बृहन्मुंबई महानगरपालिका
मुंबई अग्निशमन दल

विषय: Minutes of Meeting on PEATA / MCHI Representation.

SUB: MINUTES OF MEETING ON PEATA / MCHI REPRESENTATION

FIRE TOWER SKETCH - FOR BUILDING HEIGHT ABOVE 70MT

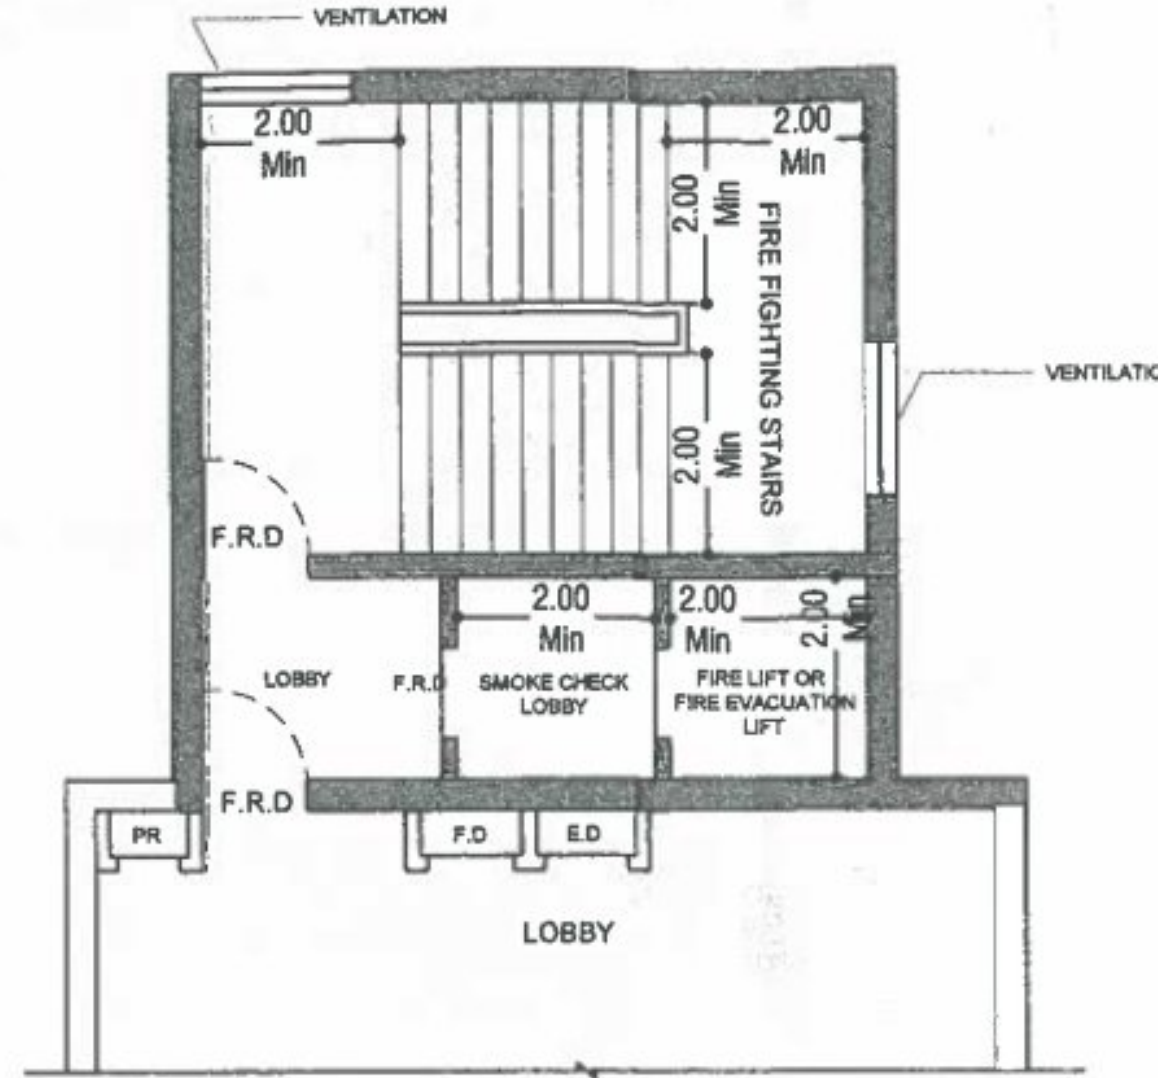
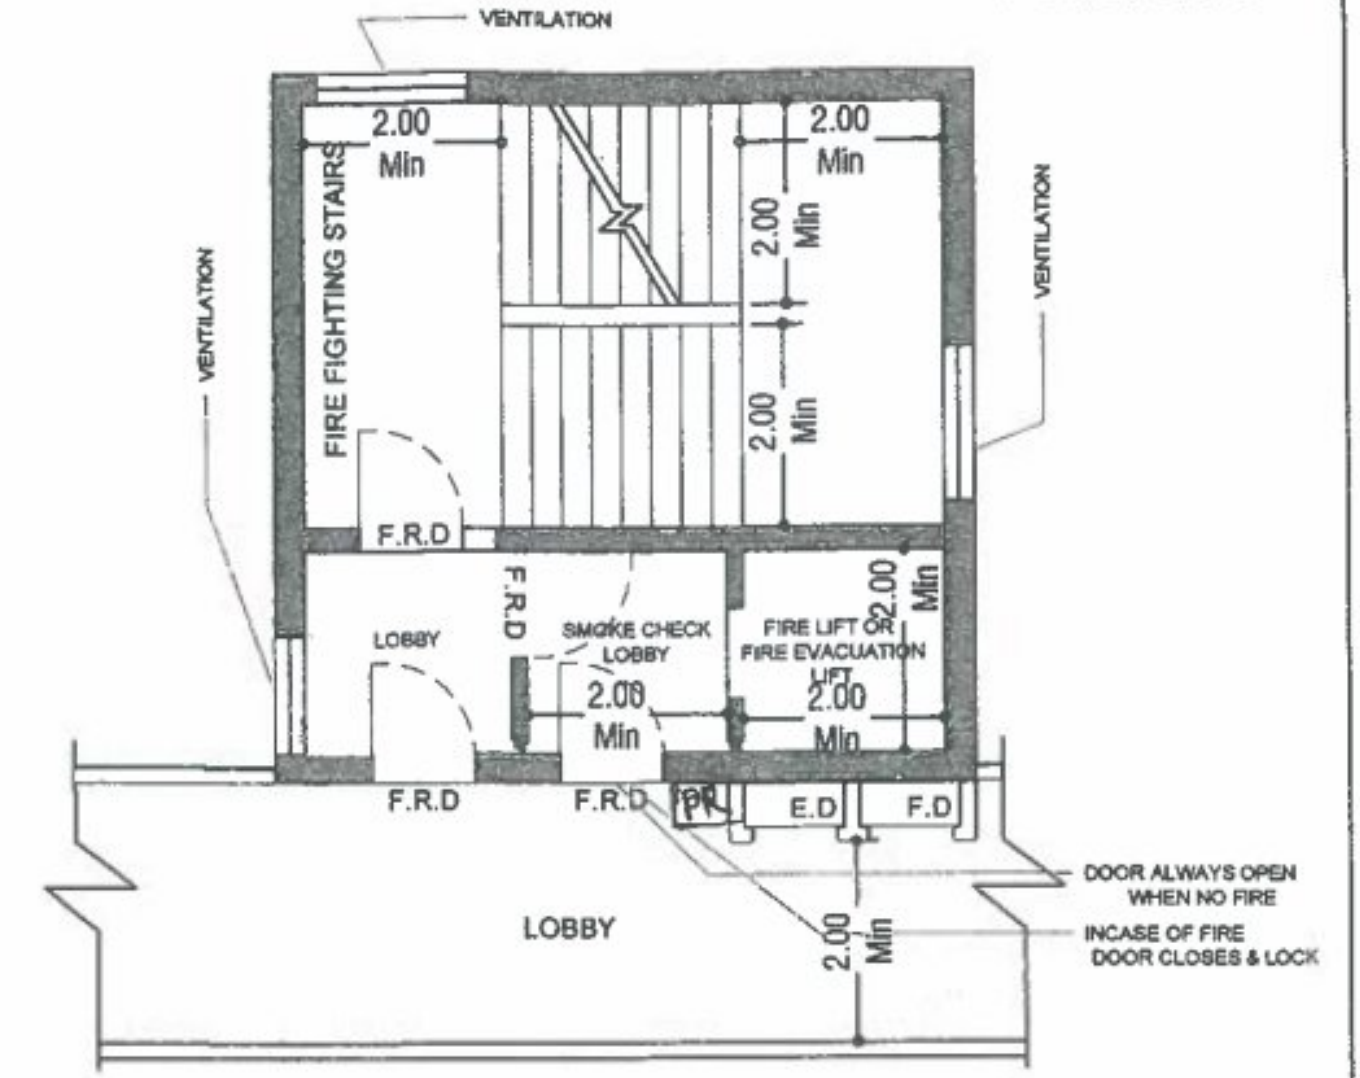
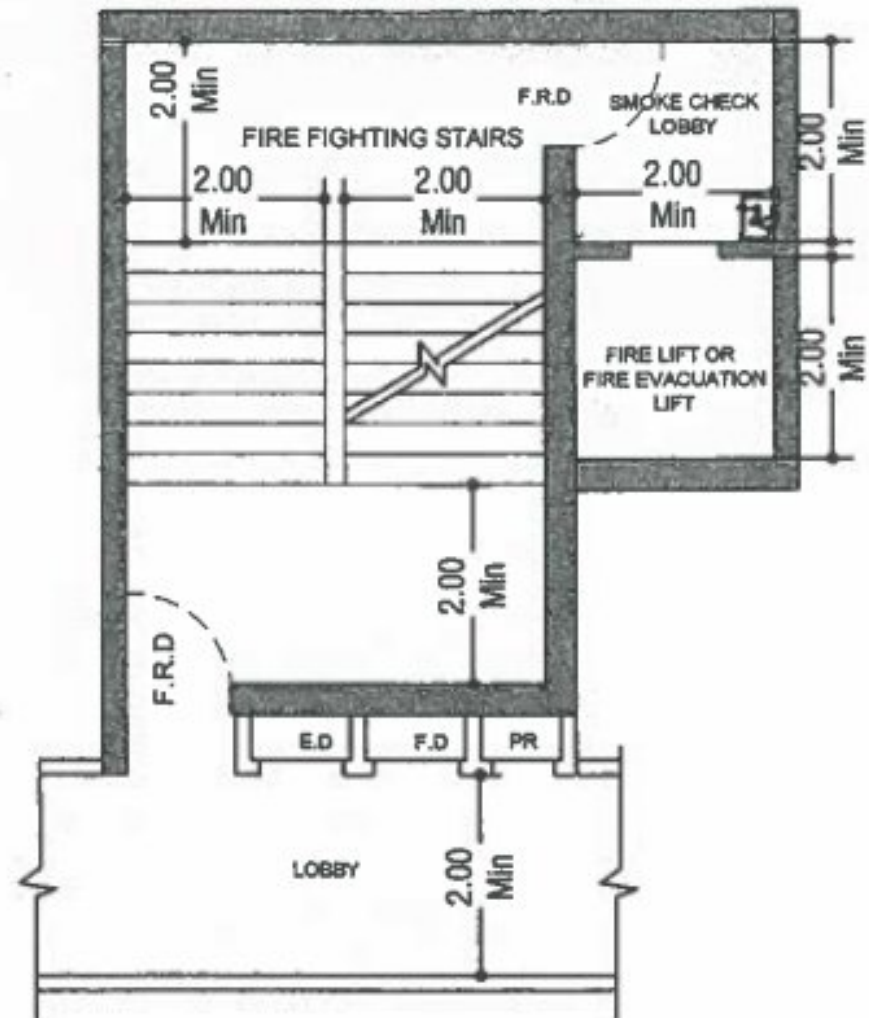
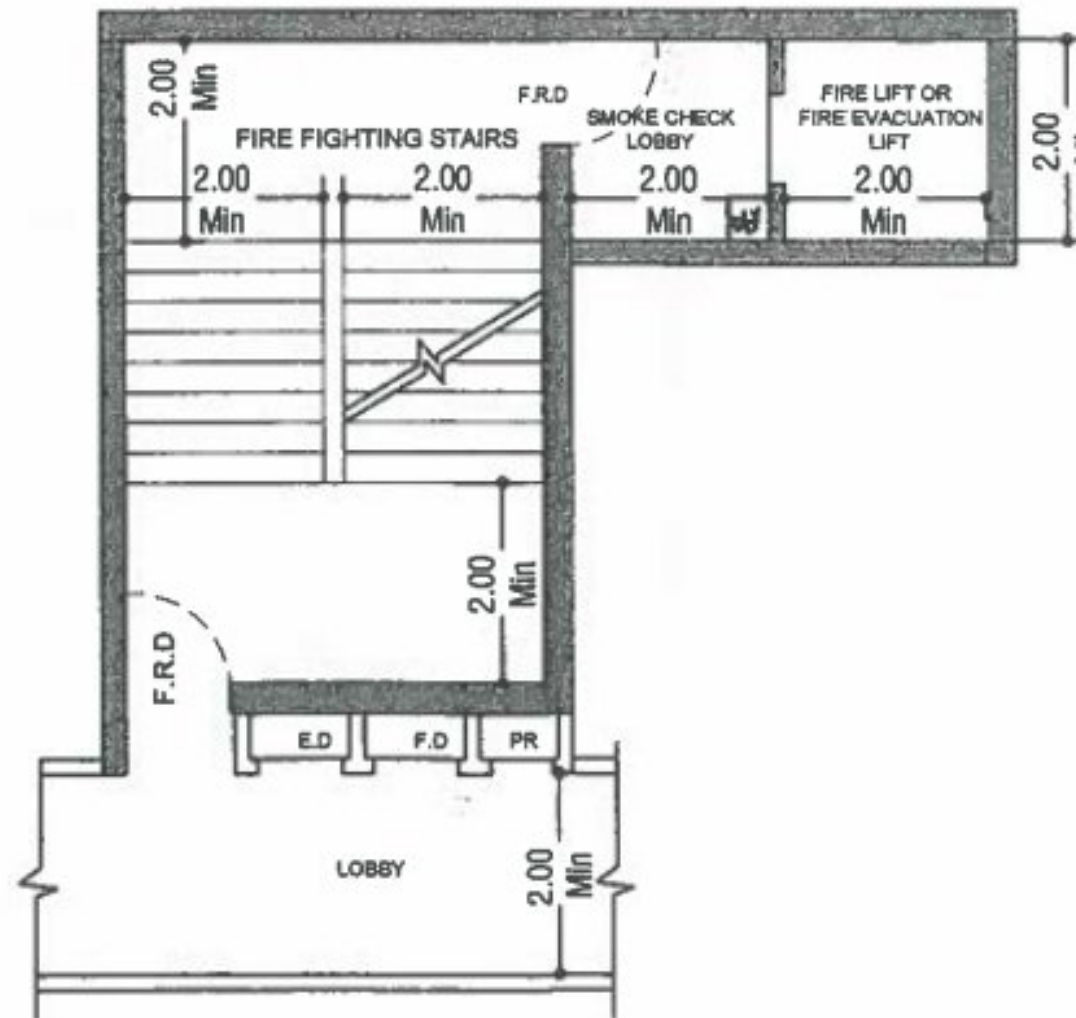
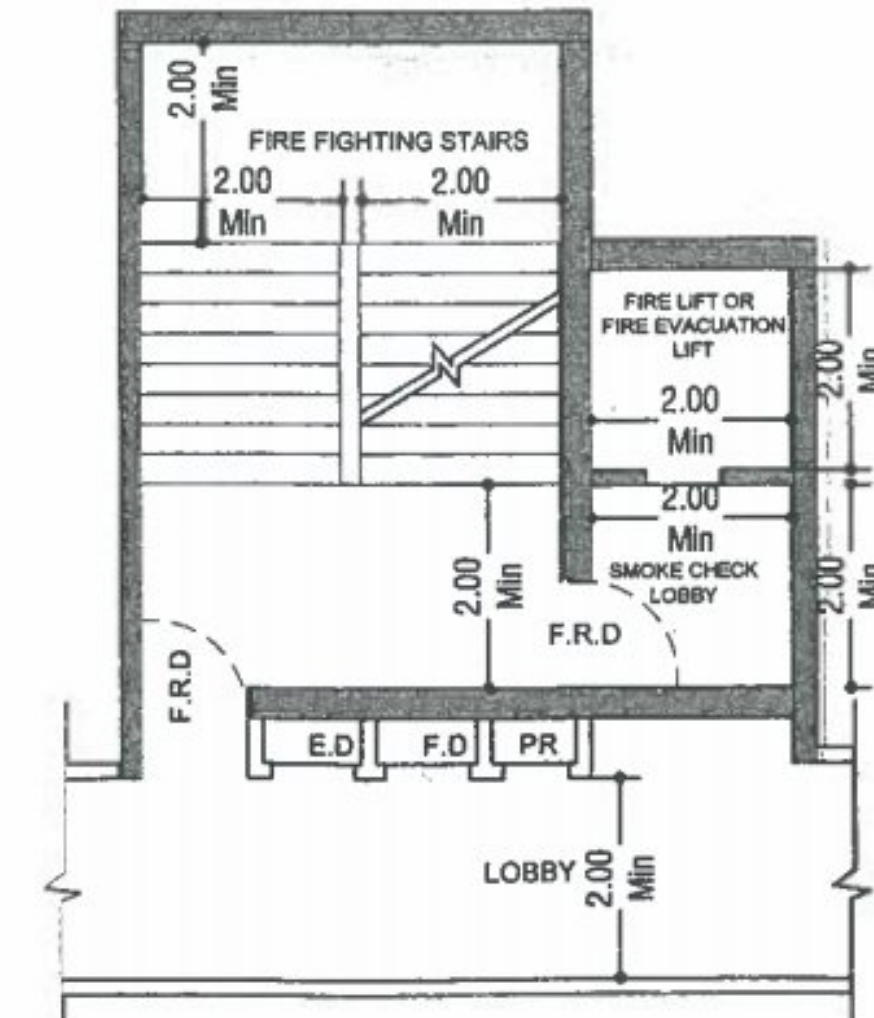
array of the sprinkler and façade should not be more than 600 mm centre to centre Distance for such sprinklers should not be less than 3.5 m (Sketch enclosed)
E Fire Tower & External Fire Evacuation System			
12	Provision of Fire Tower & External Fire Evacuation System as Reg. 48 (9)(B) of DCPR 2034	<p>As per DCPR Regulation 48 (9) (B) two type of systems any one of which provided shall be Agreed.</p> <p>Provision of Regulation reads as below:</p> <p><i>"For High Rise Building having height more than 70m shall be provided with <u>Fire tower</u> at Landing / Mid-landing Level with Smoke Check Lobby with Firemen's Lift being integral part of the Fire Escape Staircase <u>or Fire Evacuation Lift</u> (Hydropneumatics' / electrically operated) on external face of the building having opening within the fire escape staircase at landing / mid-landing level with smoke check lobby as approved by CFO shall be provided.</i></p> <p>Fire Tower if proposed shall be as per General arrangement of Fire Tower as per NBC and/or as per report of the expert Committee regarding Special Safety Regulations formulated by High Court in respect of Man made disasters.</p> <p>Fire Evacuation lift if proposed shall be as per General arrangement and shall be as per sketches approved by CFO</p>	<p>Agreed as per sketch enclosed.</p> <p>Fire Evacuation lift of min. load capacity of 1000 kg (for fresh proposals) if proposed shall be generally as per General arrangement and it shall be as per sketches enclosed so that double redundancy for the fire evacuation lift is achieved.</p>

- NOTE- 1) STORE ROOM / SERVANT ROOM OPENING IS NOT ALLOWED IN STAIRCASE.
- 2) LAYOUT TO BE PLANNED AS PER PROJECT BASIS MEETING ABOVE REQUIREMENTS.
- 3) SMOKE CHECK LOBBY CAN BE VENTILATED OR PRESSURIZED.
- 4) SMOKE CHECK LOBBY - SHALL BE 75MM ABOVE MAIN LOBBY.
